Check report by Sales + CR after finishing stage IV (Apartments)

Flat No	302	Other		Sl. No.	43111
Company	MRCV LLP	Project	BRCV	Phase	
Prepared by	Venkat Reddy	Sign		Date	5/9/24
Project Manager	Sarwar	Sign		Date	5-9-24
Stage II report no.					
Checked By MD on		MD Sign		For filling	☐ Yes ☐ No
Recommendation:					
☒ Work is satisfactorily completed. Possession may be handed over.					
☐ Minor corrections given herein to be completed before handing over possession.					
☐ Major corrections required. Do not handover possession. Request for recheck after completion of works.					
☐ Works incomplete. Check report cannot be prepared. Request for recheck after completion of works.

Details of Additions & Alterations

Flat No	302	Type	Deluxe / Semi-Deluxe
Buyer Name	M.S. Padmalatha		
Phone No.	9247667614	Email	padmalathamosi1966@gmail.com

Description First Floor Typical Flat - 102,104,106,108,110	Direction N	Owners & Developers Modi Realty Genome Valley LLP	Date 06.09.2021	Prepared By Imran	Approved By Soham Modi	Promoted by Modi Properties Pvt Ltd
		Project Name & Phase RRGV	Scale N.T.S

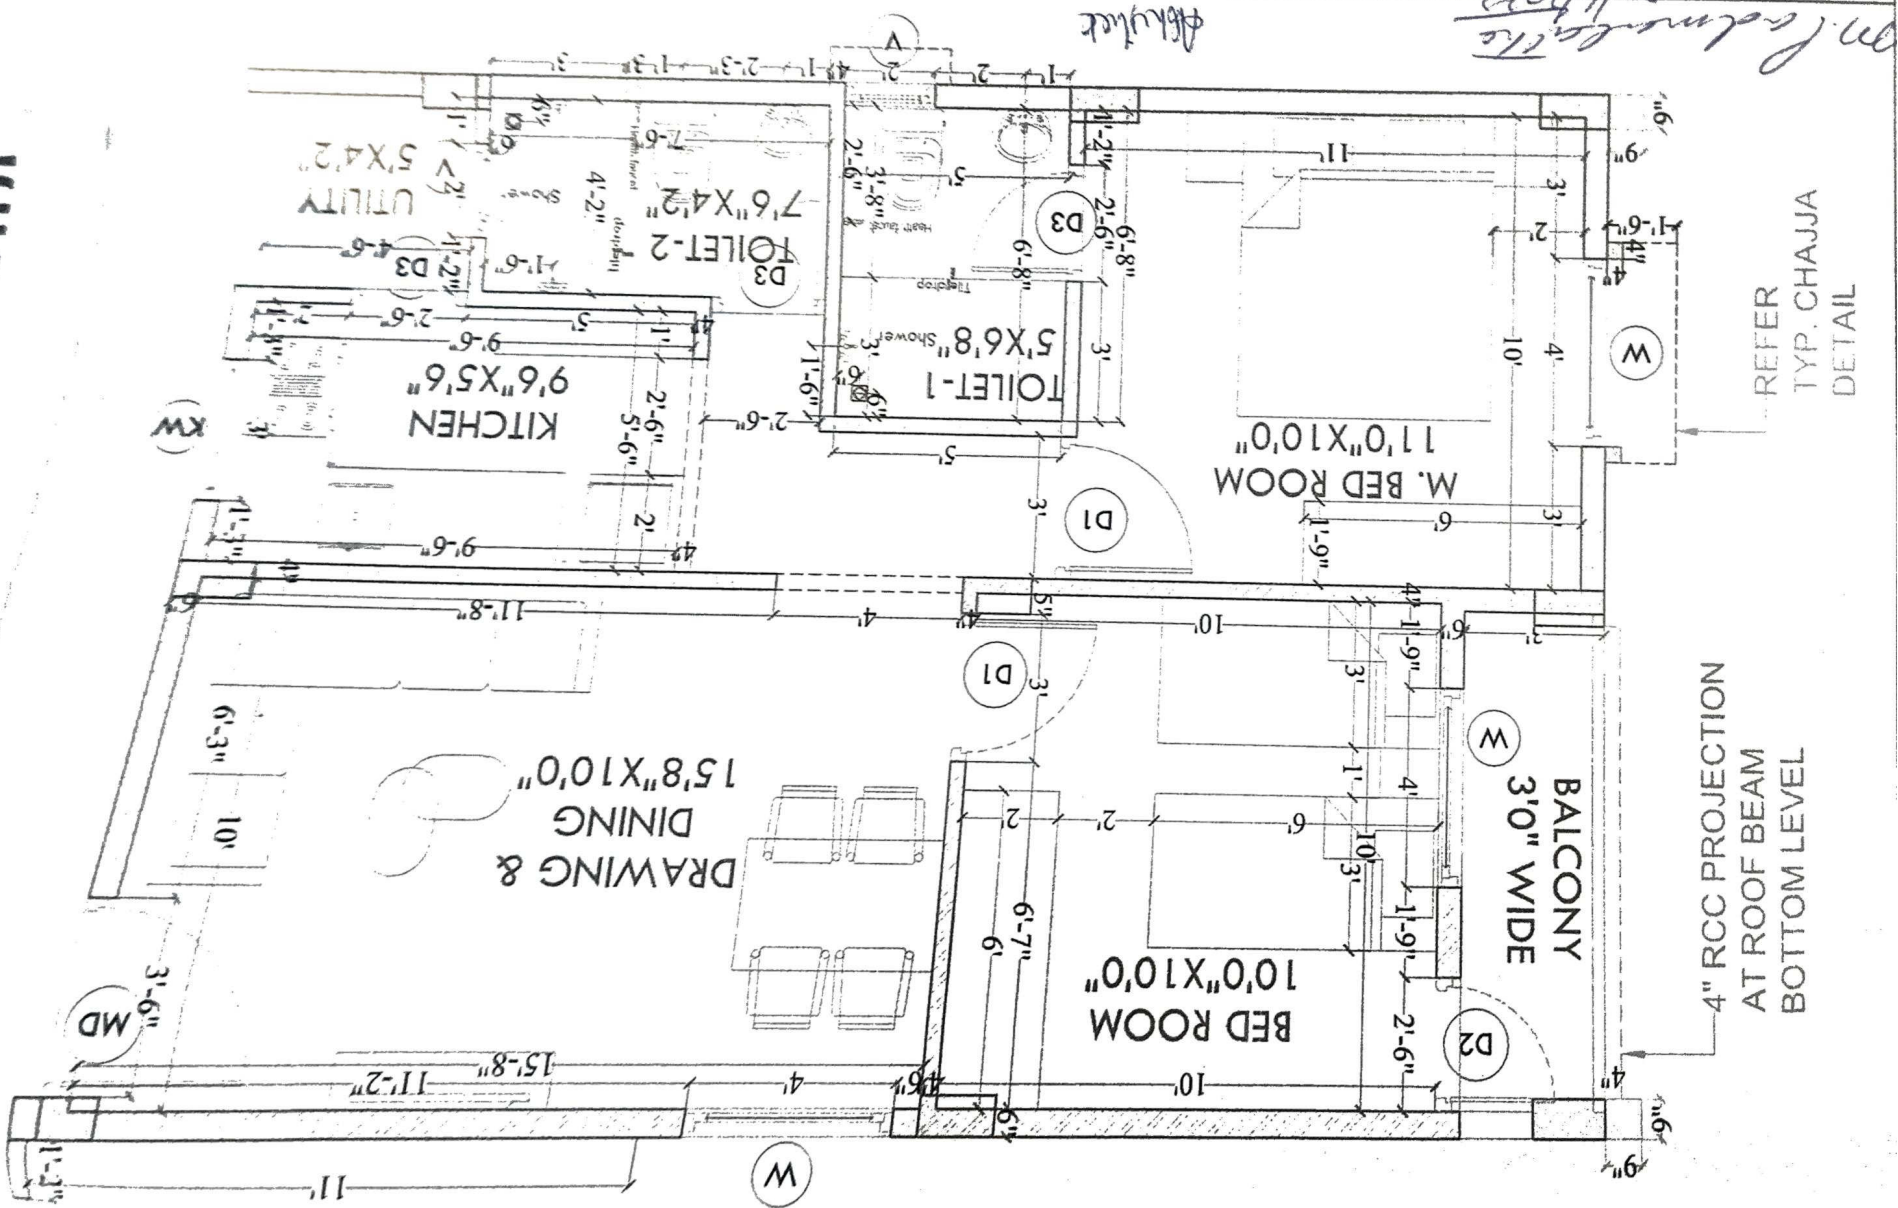
- 1) 16 Amps socket in Utility ① No's
 - 2) 16 Amps socket in kitchen for fridge ① No's
- Mentioned in drawing.
